11-21 Petrel Street, GEELONG WEST

Planning Permit Application

Application No: PA2403459

Officer Assessment Report
Development Assessment

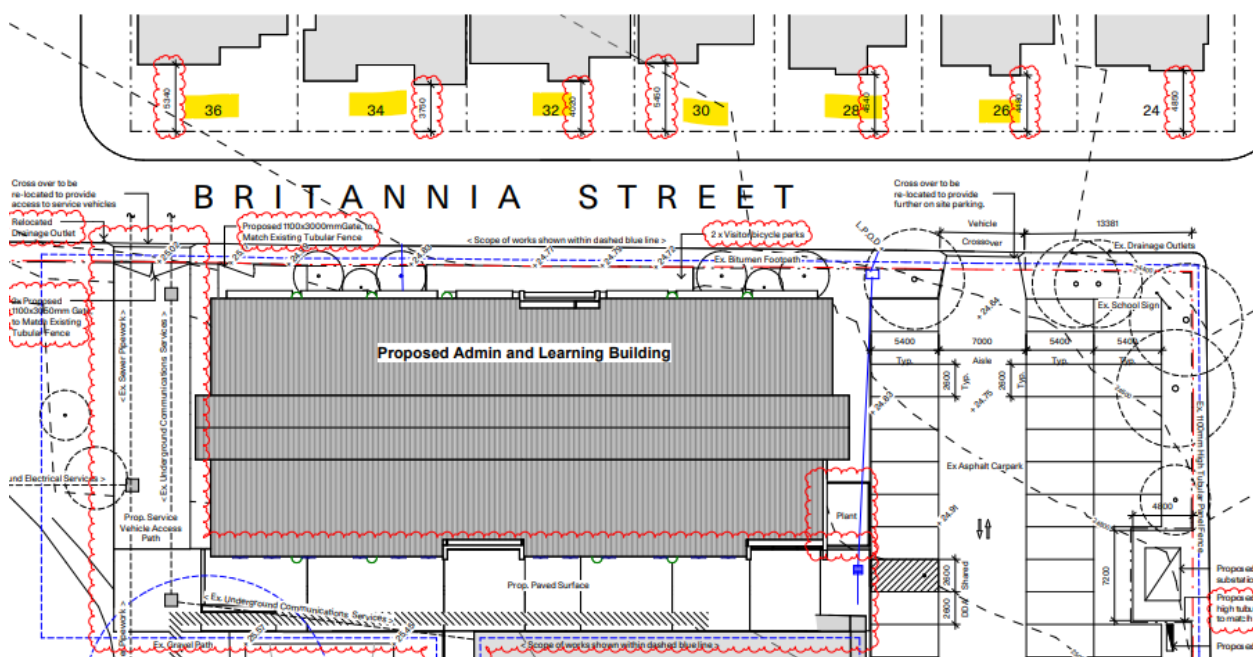
DTP Urban Design Comment	Applicant RFI Response
Reduce the overall perception of large massing and the bulk of the building by fragmenting the façade along the Britannia Street interface.	<ul style="list-style-type: none"> • Following further consultation with DTP, the design of the building has been amended to break up the massing of the first floor and fragment the façade facing Britannia Street. The fenestration has been adjusted, with spacing introduced. In addition, downpipes have been added to the breaks between the groups of windows as both a design and functional feature. This combination establishes grain to the north elevation of the building and introduces vertical cues, in contrast to the horizontally laid bricks and feature windows. • From a functionality perspective, the external downpipes avoid providing box guttering in the design and the issues that can arise with such guttering. • Other minor changes to the northern elevation include the partial removal of the fence surrounding the Britannia Street entrance of the building, allowing the steps to be brought forward to the property boundary, creating a greater sense of interaction and cohesion with Britannia Street. • An Urban Design Response Report has been prepared and submitted in support of this response. This report provides a more in-depth response discussing how the revised design has addressed the comments of DTP's Urban Design team.

Seek to retain mature trees and incorporate them into the design.	The trees to be removed are of poor quality, planted, and introduced species, some of which classify as weeds. The landscaping proposed allows for ample opportunity for replacement plantings which will achieve a softening and screening effect whilst being more appropriate species which are indigenous and hardy.
We query the existing chapel's heritage value and, if it is allowed to be demolished, whether any of the bricks were repurposed in this proposal to maintain and contribute to the neighbourhood's character.	As the bricks are not of heritage significance and do not complement the design of the proposed building, they are not proposed for repurpose. This position has been reaffirmed by the council's Heritage Advisor who provided no objection to the demolition and noted that there were no statutory heritage

35. On 10 April 2025, DTP UD reviewed the RFI response package and confirmed that the design changes are an improved outcome from what was originally submitted.

Figure 13: North elevation facade window configuration revision

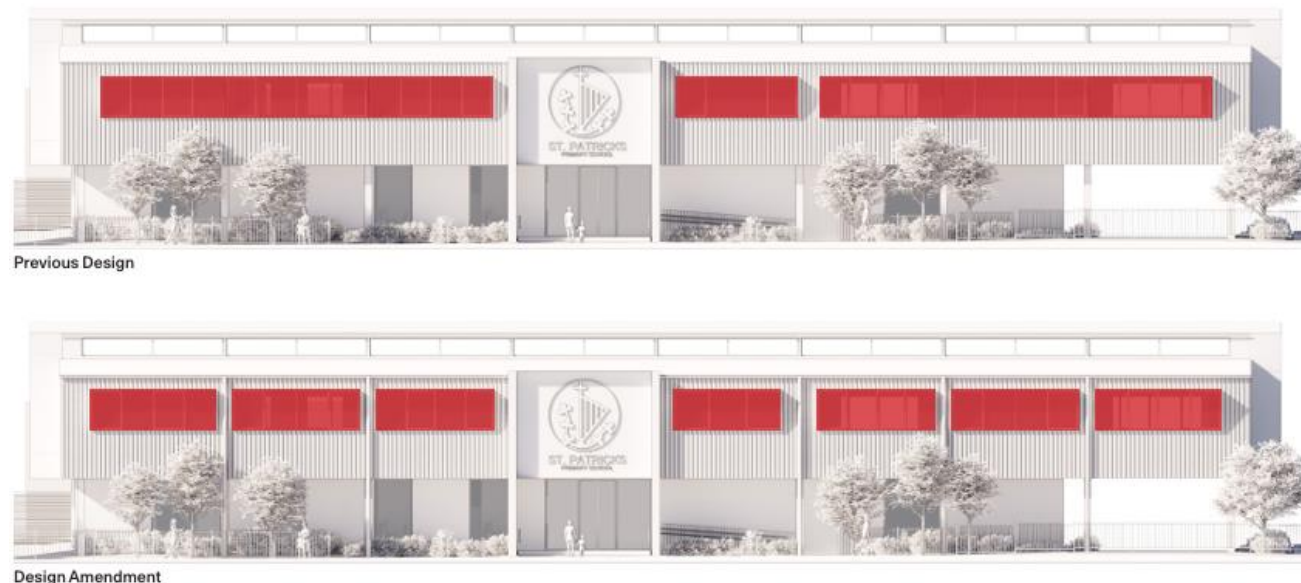
50. The north elevation fronting Britannia Street went through a number of design revisions to address massing issues while retaining the floor space needed to accommodate additional capacity. By positioning the windows between the stainless-steel downpipes, vertical breaks are created that in turn refine the façade and reduce visual massing. In addition, the proposed cladding colour had been changed from Monument Colourbond to Woodland Grey. The lighter and more muted tone mitigates the visual prominence of the first floor built form and better compliments the façade materiality. The colour of the north elevation window shades has been revised to a copper/bronze tone to compliment the revised cladding and provide further variation to the façade's articulation. The changes are considered positive in respect to the originally proposed design (Figures 13 & 14).
